**TOWN OF NEWBURGH
PLANNING BOARD
TECHNICAL REVIEW COMMENTS**

PROJECT NAME: LONGVIEW FARM
PROJECT NO.: 06-39
PROJECT LOCATION: SECTION 20, BLOCK 1, LOT 1
SECTION 20, BLOCK 1, LOT 3.35
REVIEW DATE: 13 JANUARY 2023
MEETING DATE: 19 JANUARY 2023
PROJECT REPRESENTATIVE: T.M. DEPUY ENGINEERING & LAND SURVEYING, PC

LONGVIEW FARM SUBDIVISION SECTION 1, SECTION 2, SECTION 3 AND SECTION 4

DRAINAGE EASEMENT
SCALE: 1" = 100'

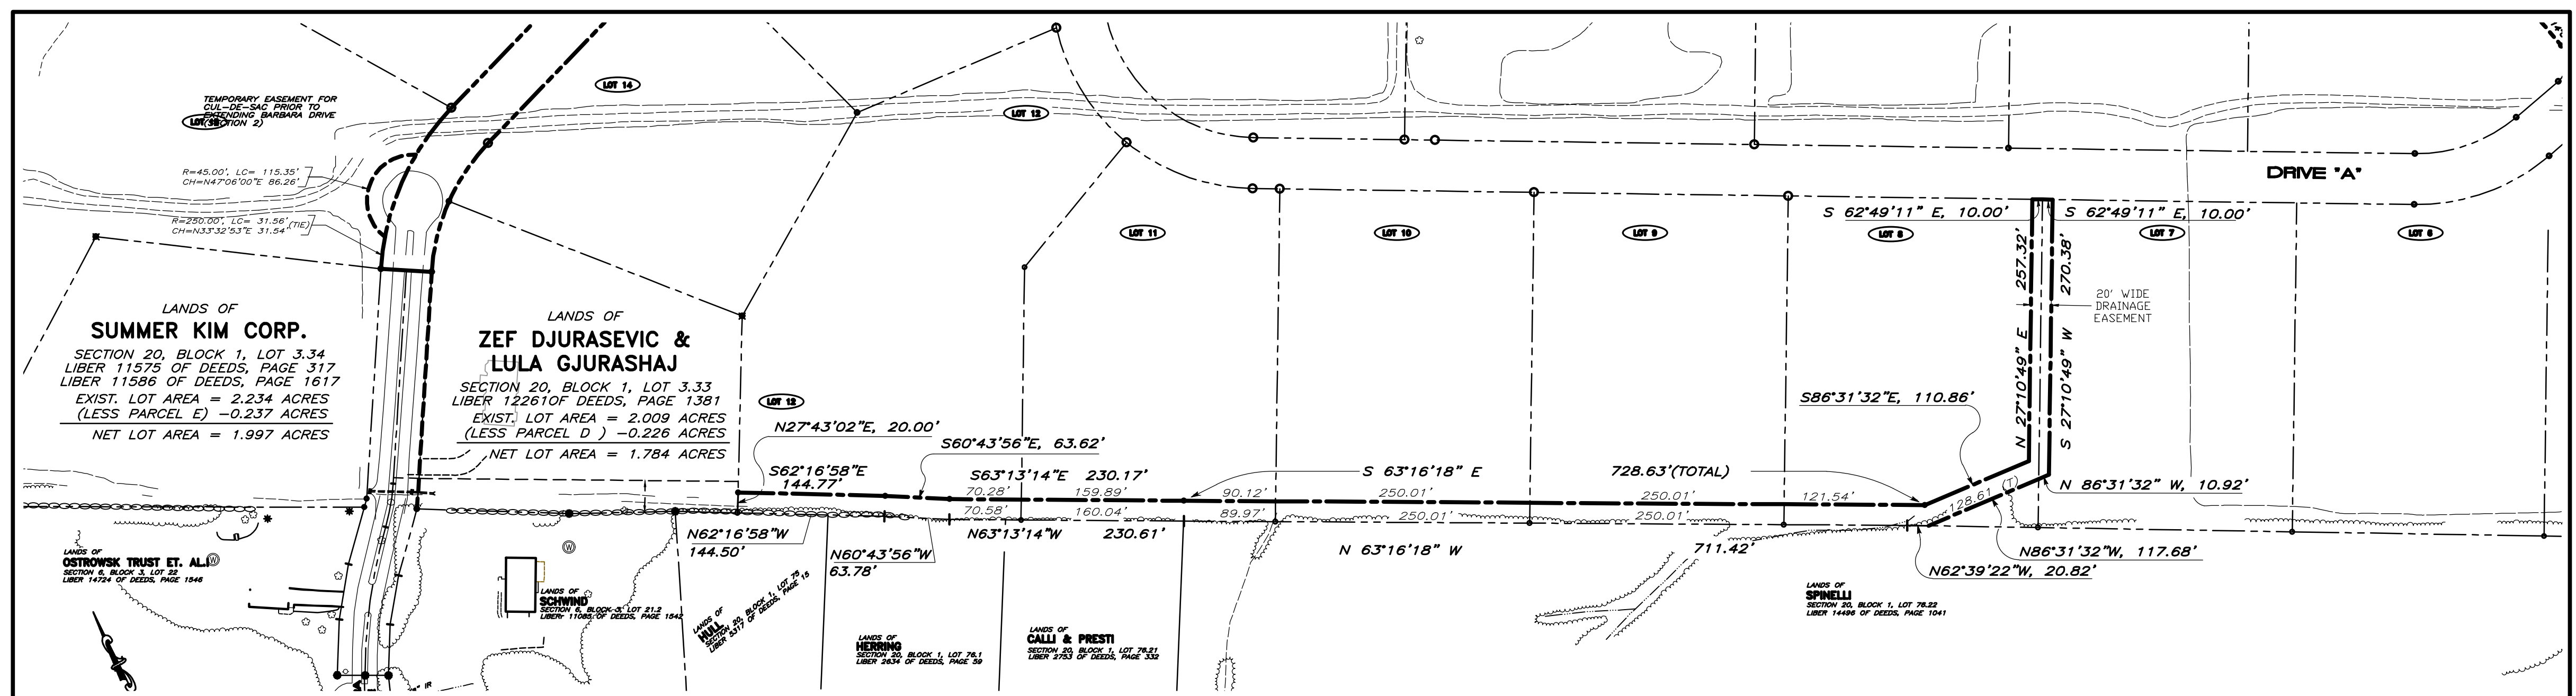
16. A drainage easement is depicted on Sheet 5, which crosses the rear of the lots 8 thru 12. It is unclear who this drainage easement is in favor of and who will operate and maintain it. The drainage district should most likely be the recipient of the easement.

THE CONCRETE CULVERT STRUCTURE WAS DESIGNED & CONSTRUCTED TO MEET H-20 LOADING
AS-BUILT CROSS-SECTION AND DETAIL
 SCALE: 1/2" = 1'-0"

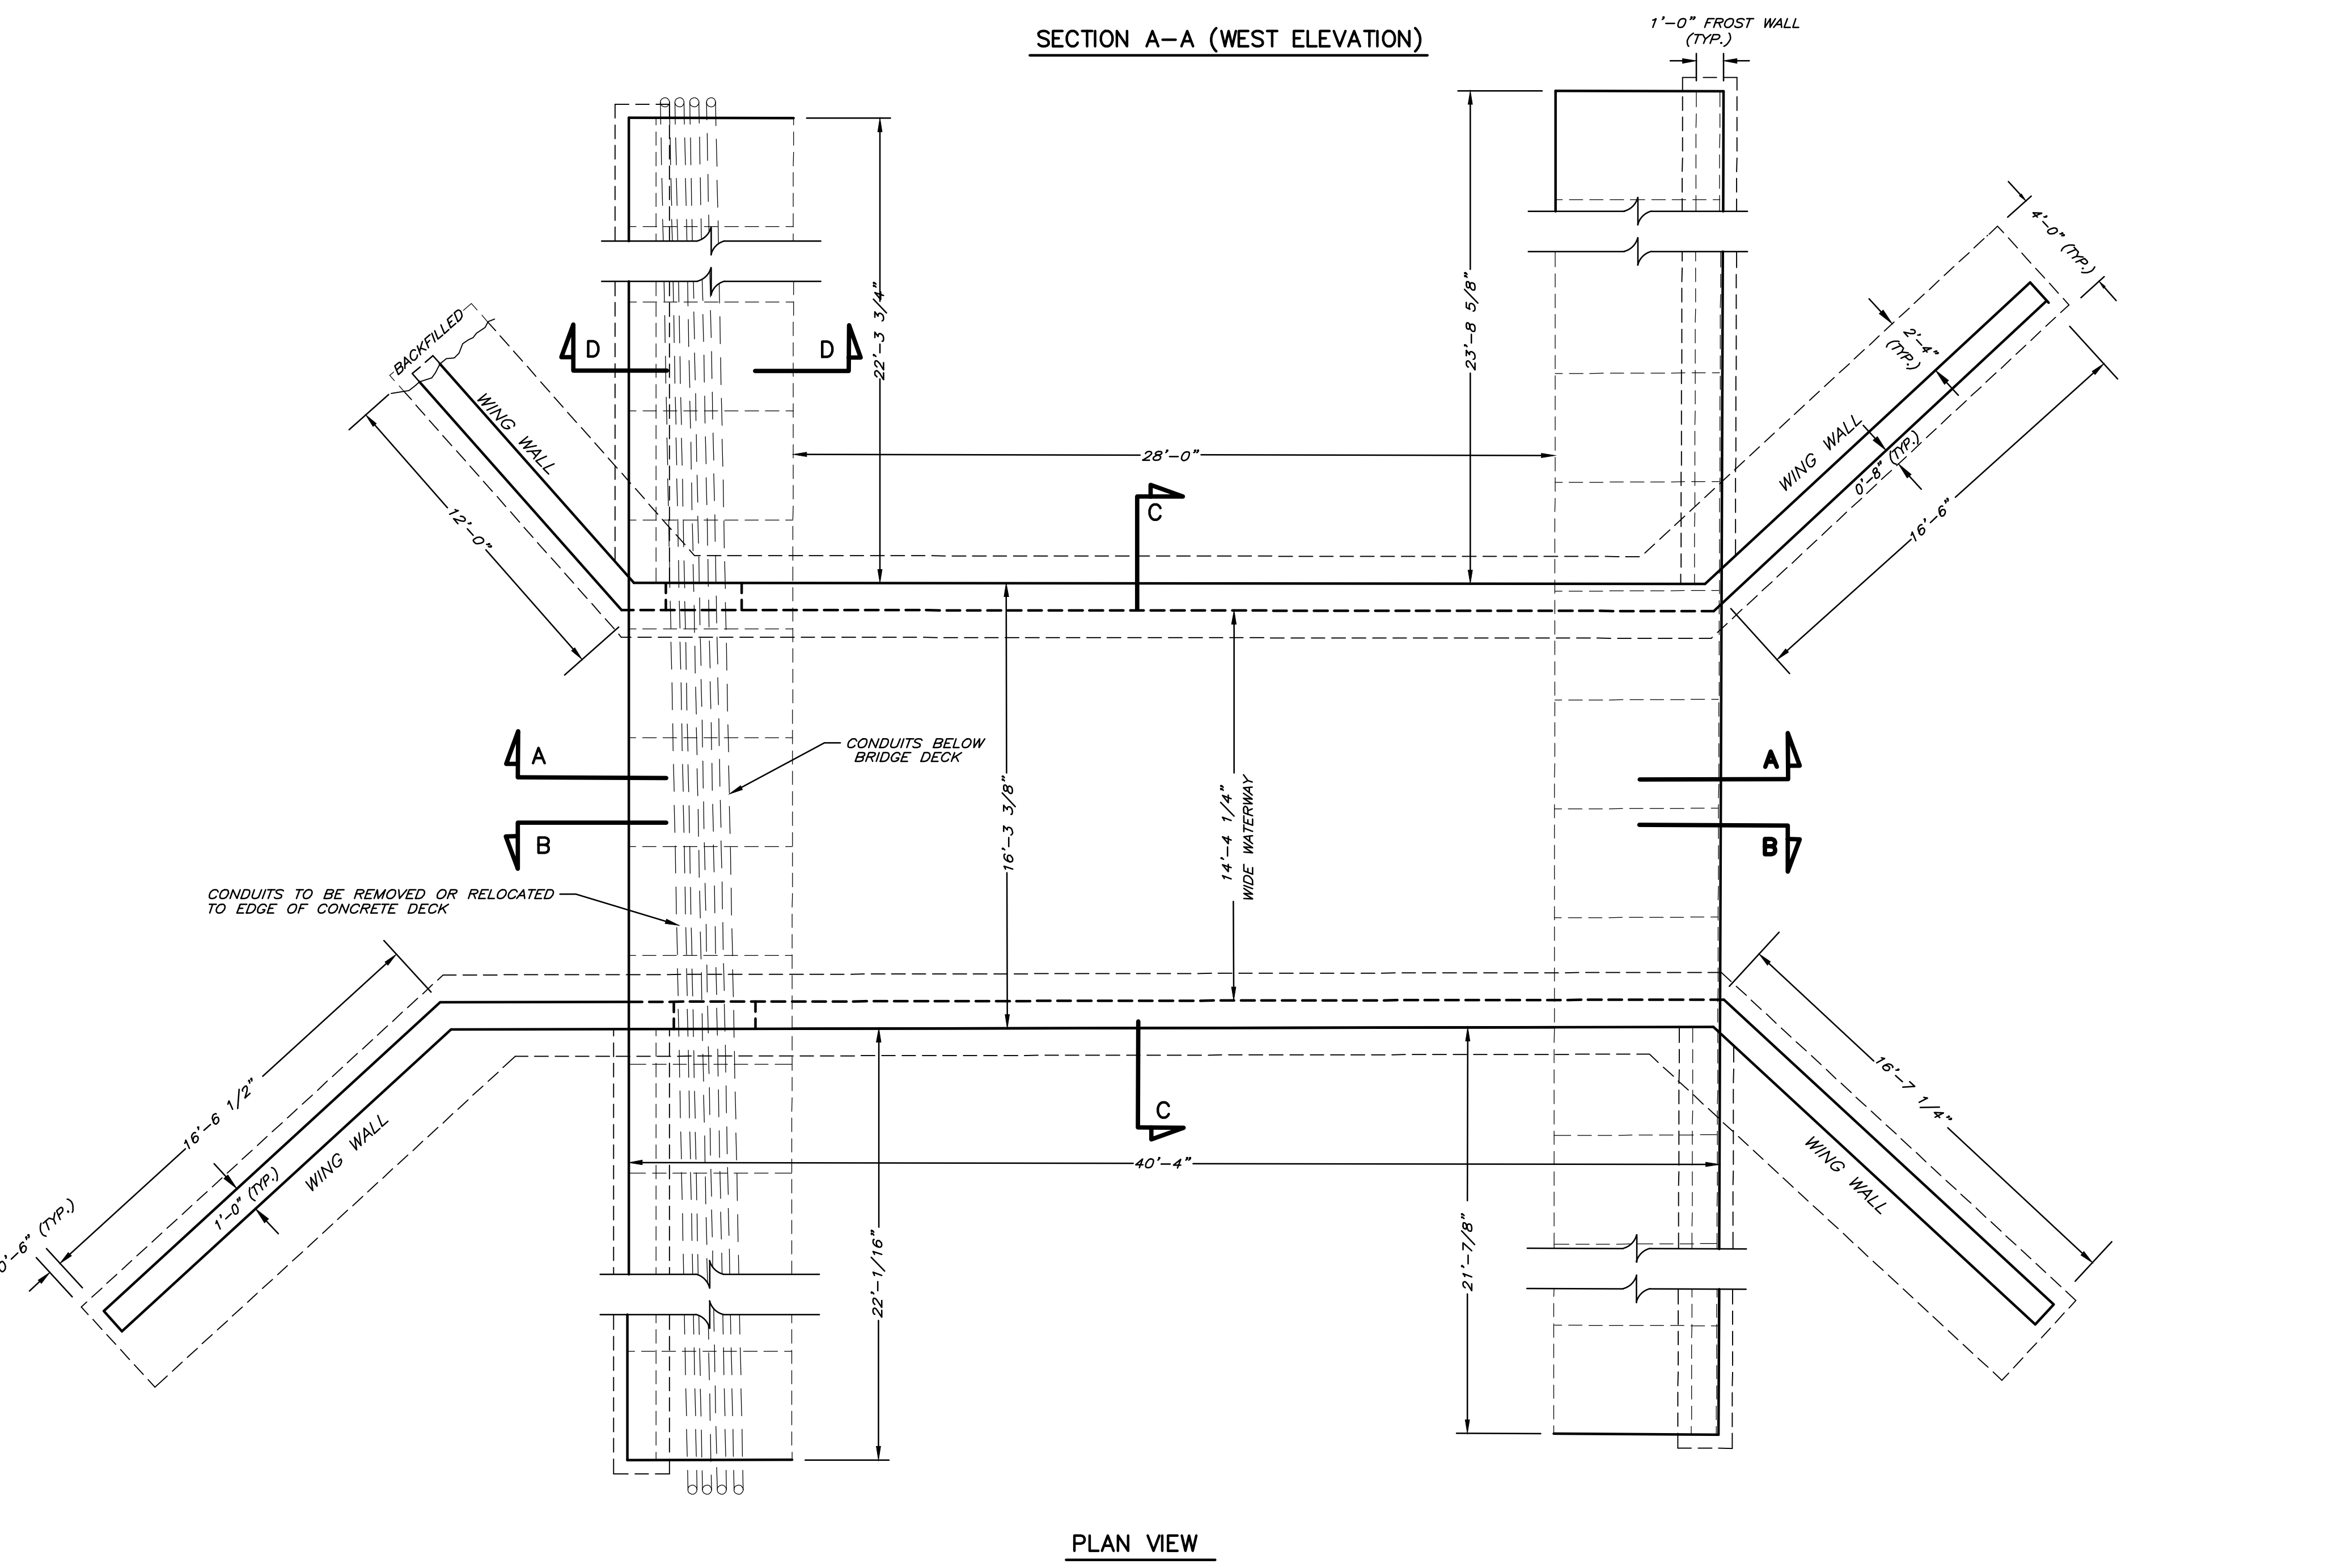
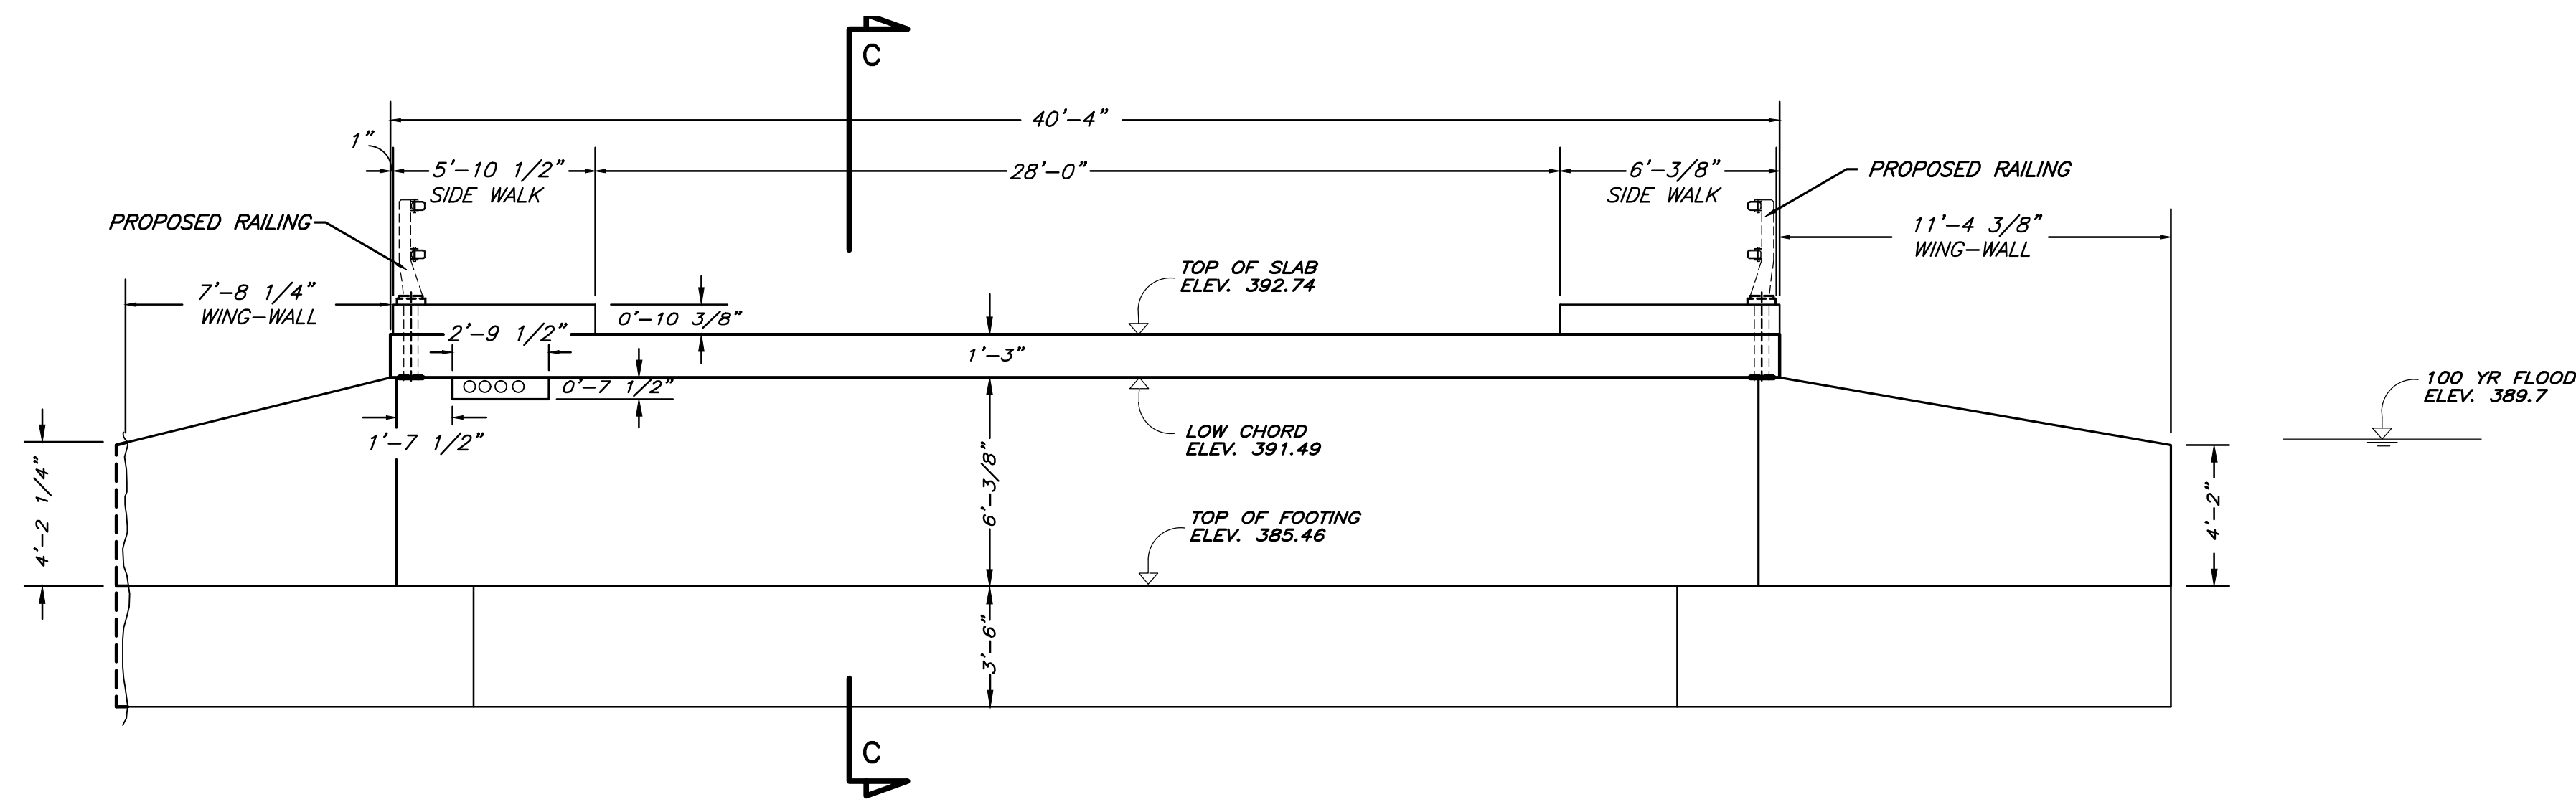
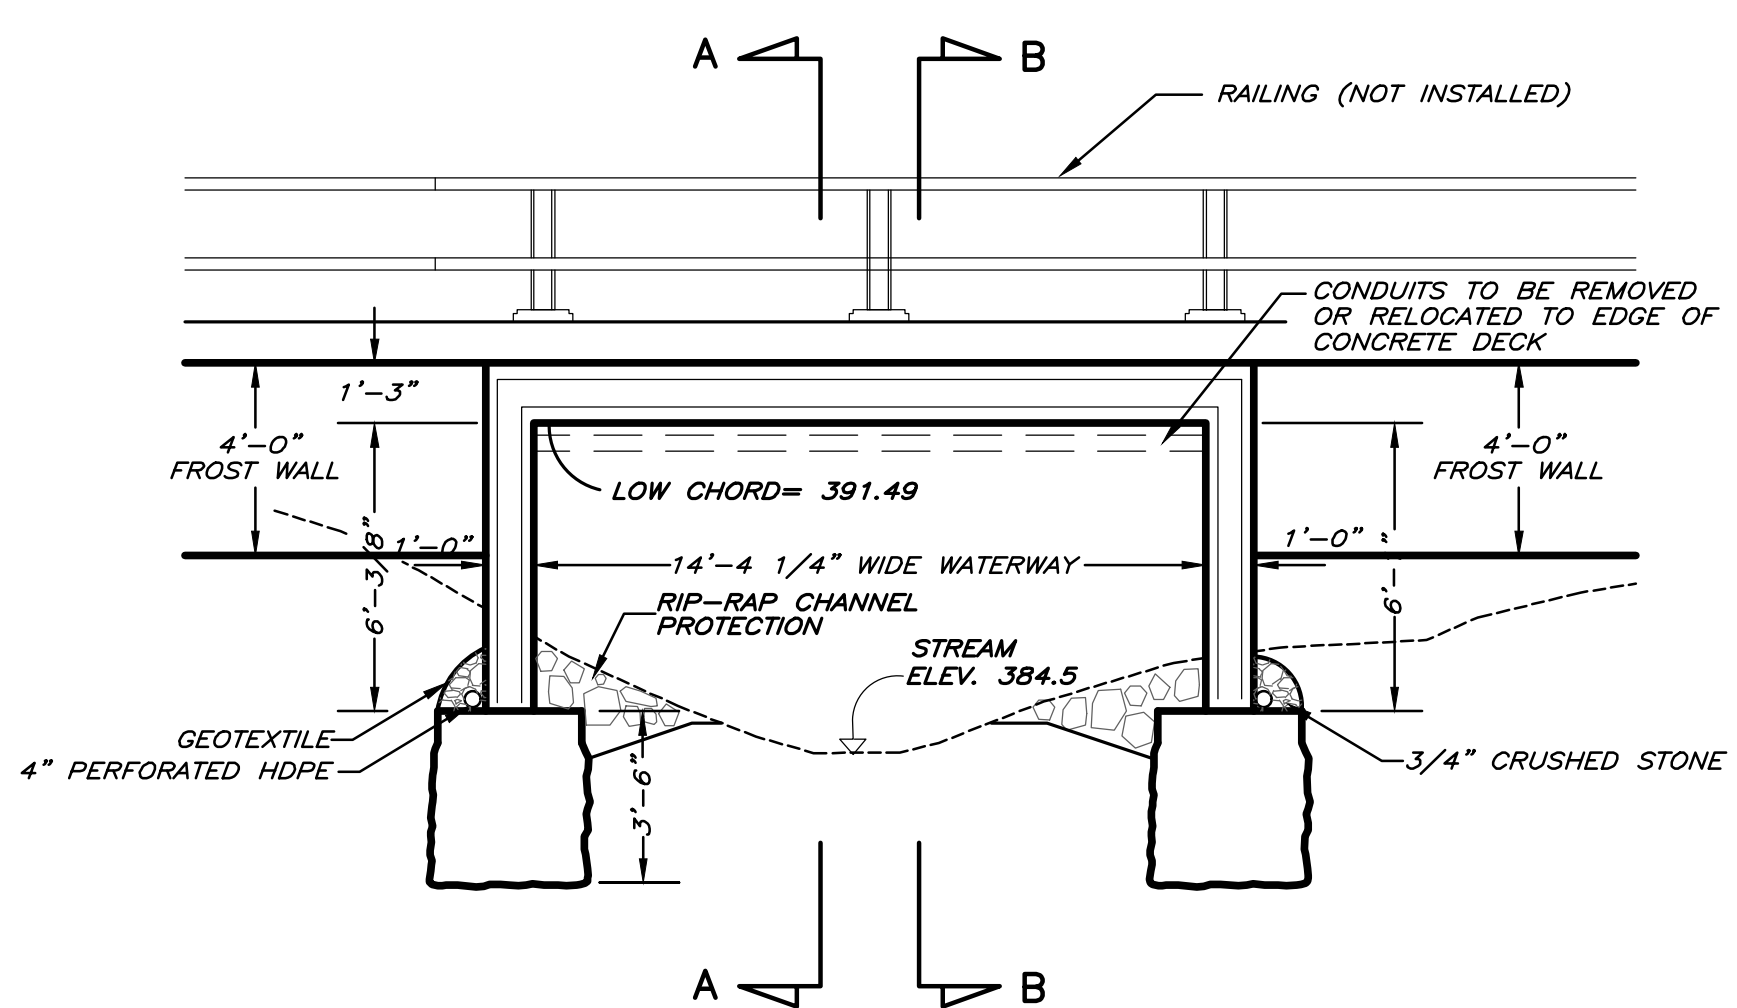
8. The proposed culvert crossing identifies sidewalks on both sides of the culvert in a 28 foot wide driving lane. It is unclear if that exists.
9. Conduits in the culvert are identified to be removed or relocated. The conduits should be removed from interior of the culvert pipe.
